Sundry Print Report

Well Name: DOME TESORO 27 Well Location: T22N / R7W / SEC 27 / County or Parish/State:

Notice of Intent

Type of Action: Plug and Abandonment

Planned P & A Schematic

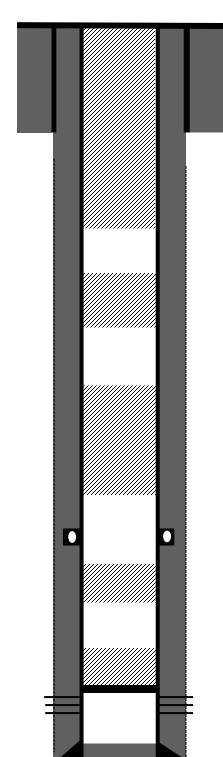
Created By		Condition Date
john.harrison	Please add 100' plug across DV tool Adhere to BLM approved COAs and plugs. See GEO report.	5/2/2023
